VLBA ARRAY MEMO No. 249

To: Bill Horne  
From: Peter Napier  
Subject: Comments on VLBA Memo No. 241.

Preliminary Subreflector  
Layout for VLBA Antenna

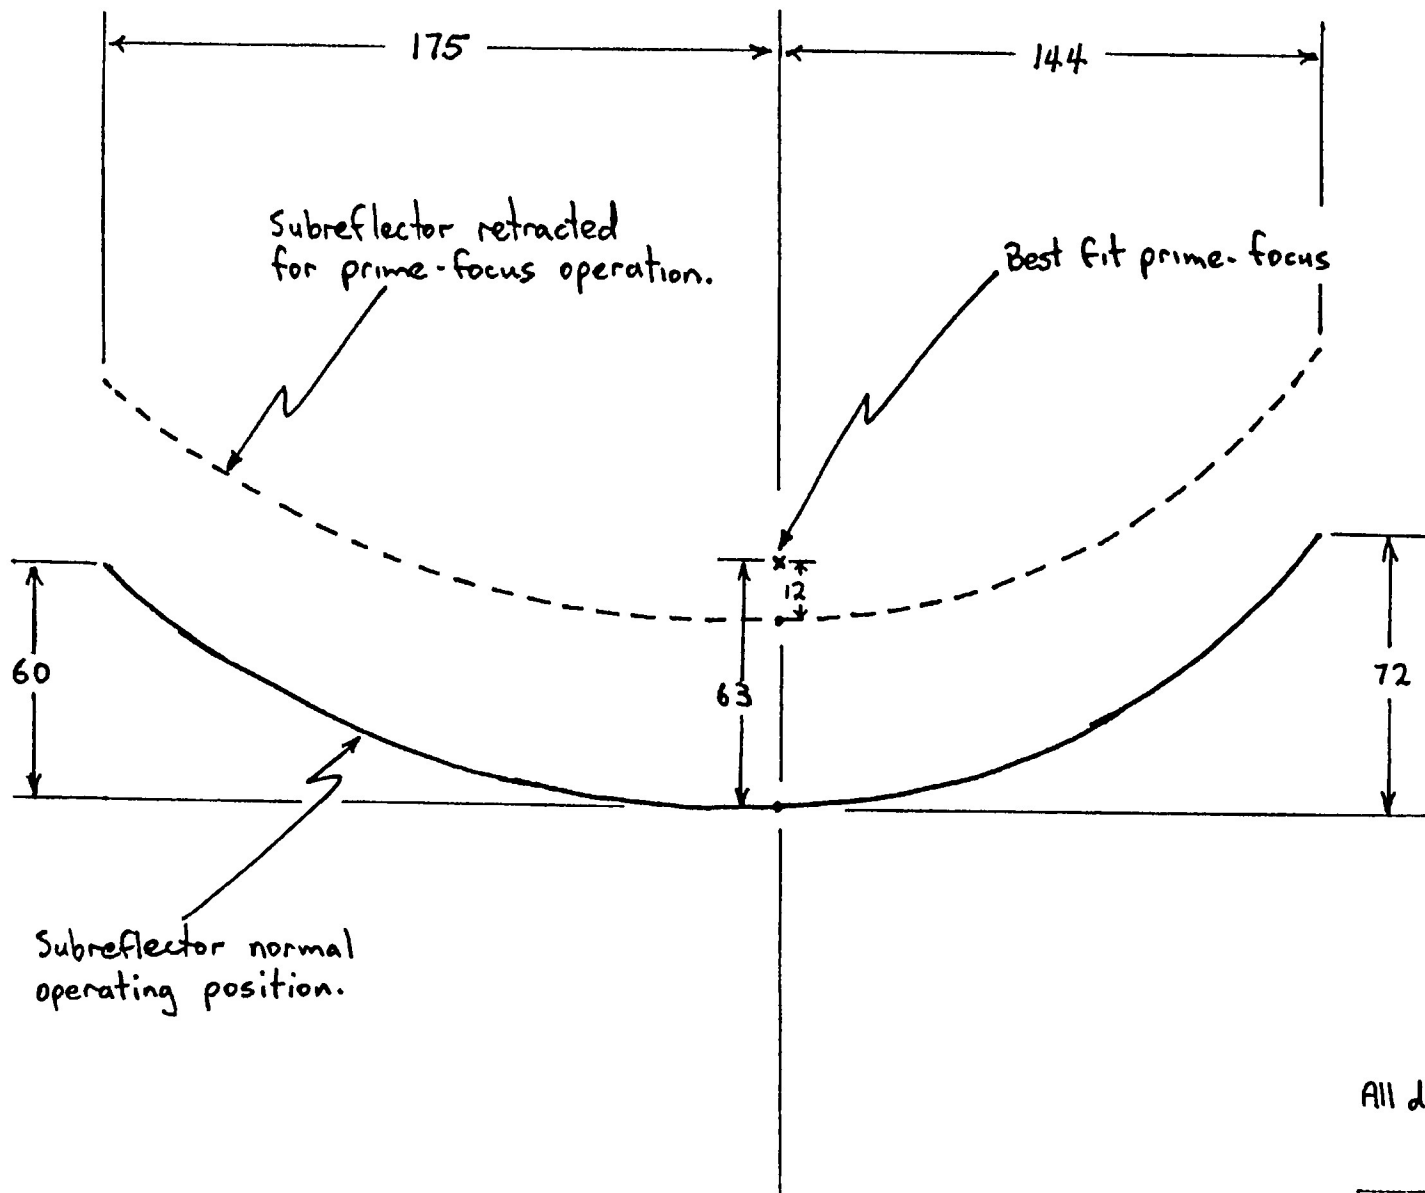
(15)Page9,Feed legs and apex. We will not have a separate prime focus receiver package. The total combined weight of subreflector,prime-focus feeds and receiver should be no more than 700lbs. I don't have final dimensions for the subreflector yet but current calculations give the dimensions shown in the attached sketch. The feed legs must provide sufficient clearance to support the subreflector in its normal operating position and also allow it to be retracted to the prime-focus operating position. I suggest we include a sketch of this type in the specs. We should call the subreflector "an asymmetric subreflector with maximum radius 1.8m".
